BROWNS FERRY NUCLEAR PLANT (BFN) - UNITS 1, 2, AND 3 -
TECHNICAL SPECIFICATIONS (TS) CHANGES TS-431 AND TS-418 -
EXTENDED POWER UPRATE (EPU) - RESPONSE TO ROUND 9 - REQUEST
FOR ADDITIONAL INFORMATION (RAI) - SBWB RAIs (TAC NOS.
MC3812, MC3743, AND MC3744)

TENNESSEE VALLEY AUTHORITY
BROWNS FERRY NUCLEAR PLANT (BFN)
UNITS 2 AND 3

RESPONSE TO ROUND 9 REQUEST FOR ADDITIONAL INFORMATION SBWB-65
THROUGH SBWB-74

Figure SBWB-65-1
Limiting Axial Power Shape (LOCA)

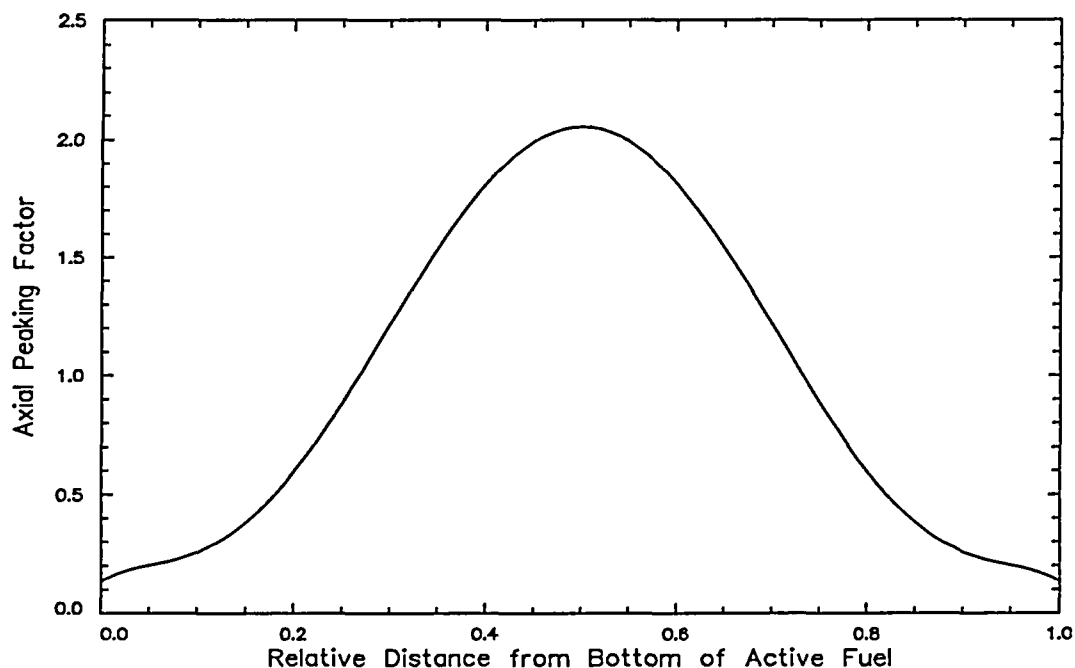
Provide the head flow curves used in the limiting large break loss-of-coolant accident LBLOCA analyses (battery failure case). The curves should include the head flow curve for one low pressure core spray and one low pressure coolant injection pump discharging into each recirculation line. Also, provide the limiting axial power shape used in this limiting break.

The limiting axial power shape in the limiting LOCA analysis is shown below in Figure SBWB-65-1.

Figure SBWB-49-2. Pump Curve for One Core Spray Loop

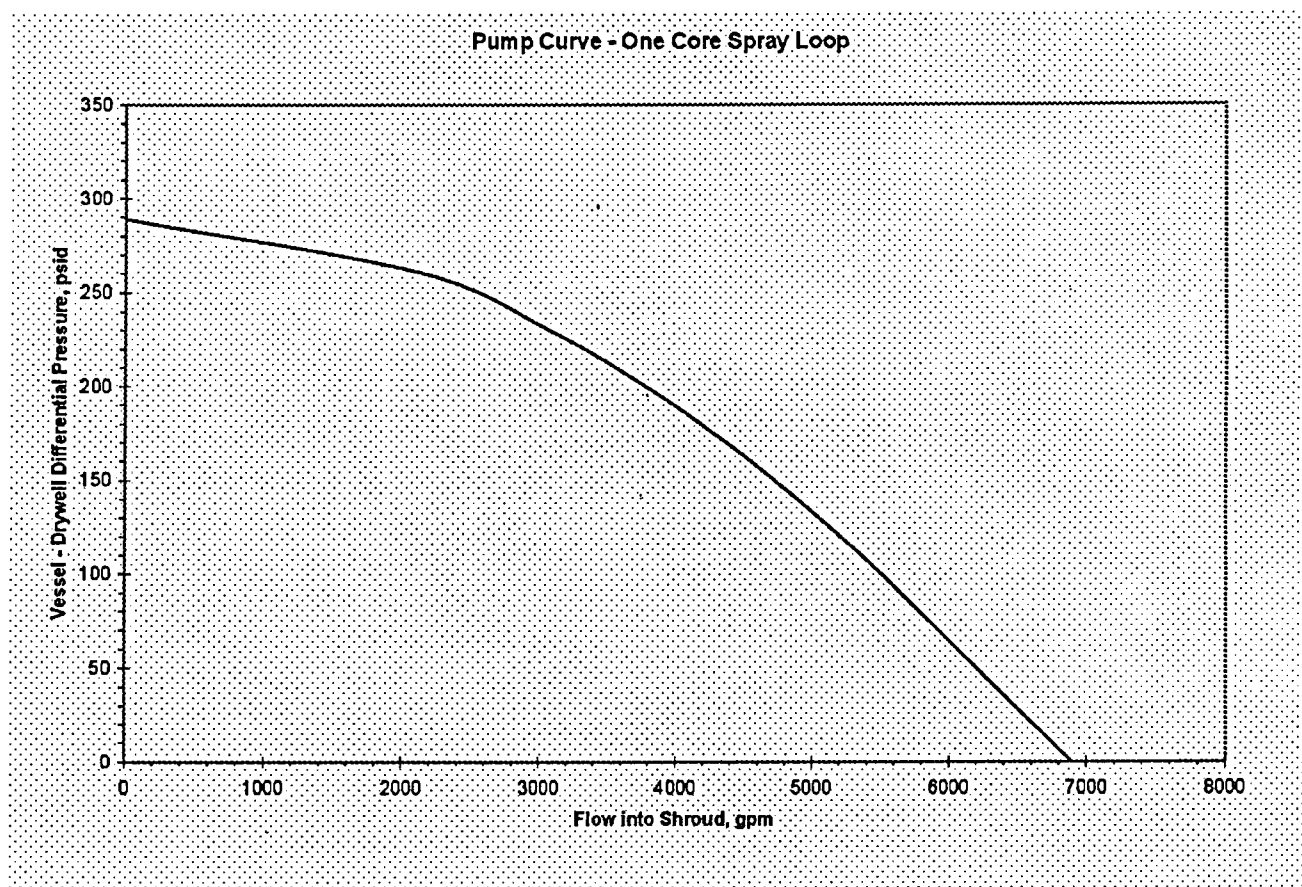
Provide the head flow curves used in the limiting large break loss-of-coolant accident analyses (battery failure case). The curves should include the head flow curve for one low pressure core spray and one low pressure coolant injection pump discharging into each recirculation line. Also, provide the limiting axial power shape used in this limiting break.

Figure SBWB-49-2 shows the flow into the shroud of one core spray loop (two core spray pumps) as a function of the differential pressure between the vessel and drywell.

Figure 3.7.1-1
Reactor Thermal Power Versus Ultimate Heat
Sink Temperature Limit

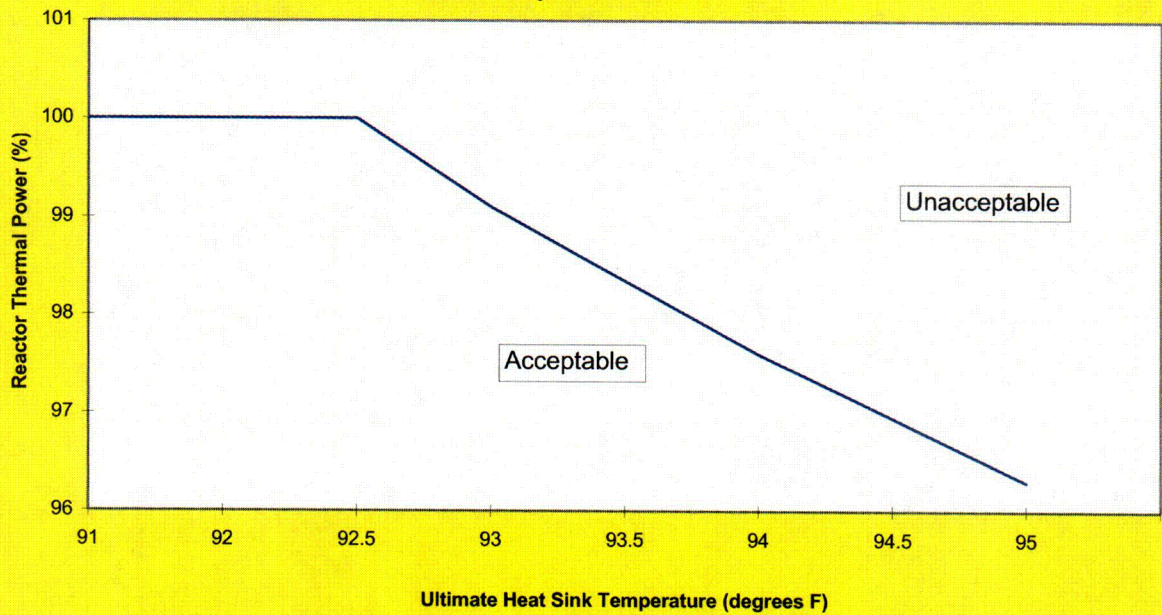
Delete
Figure.

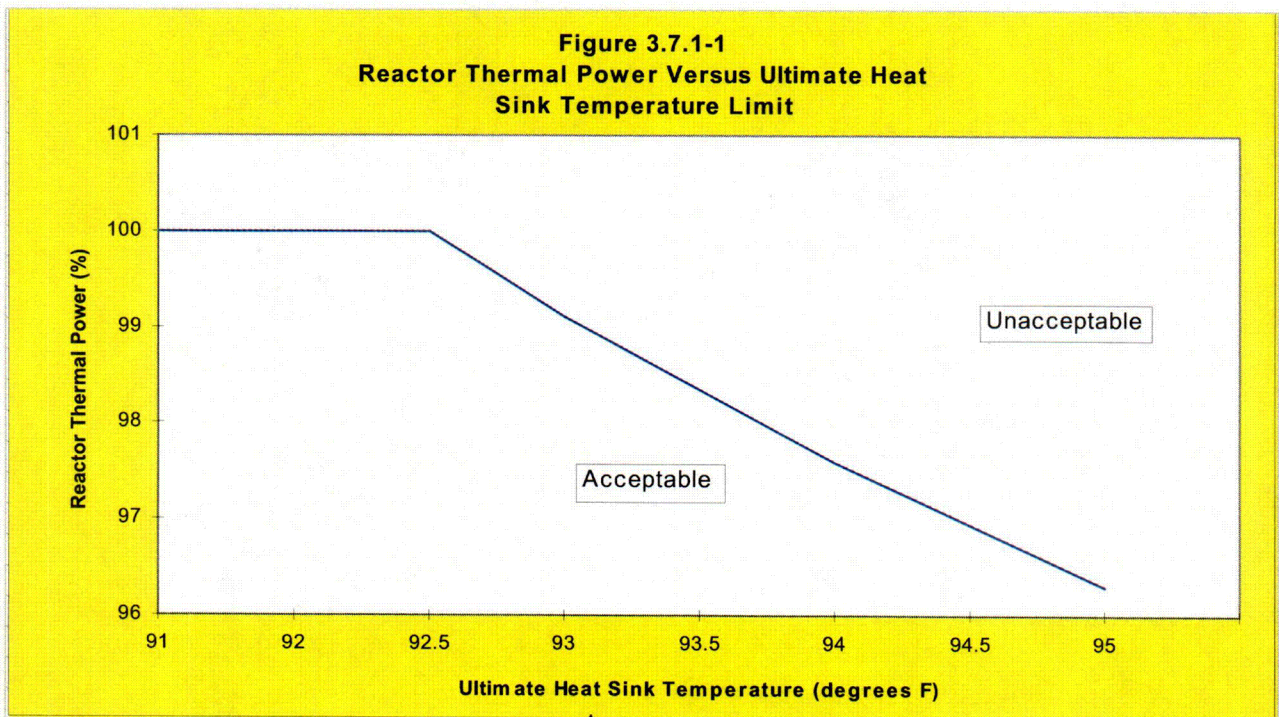
Delete Figure
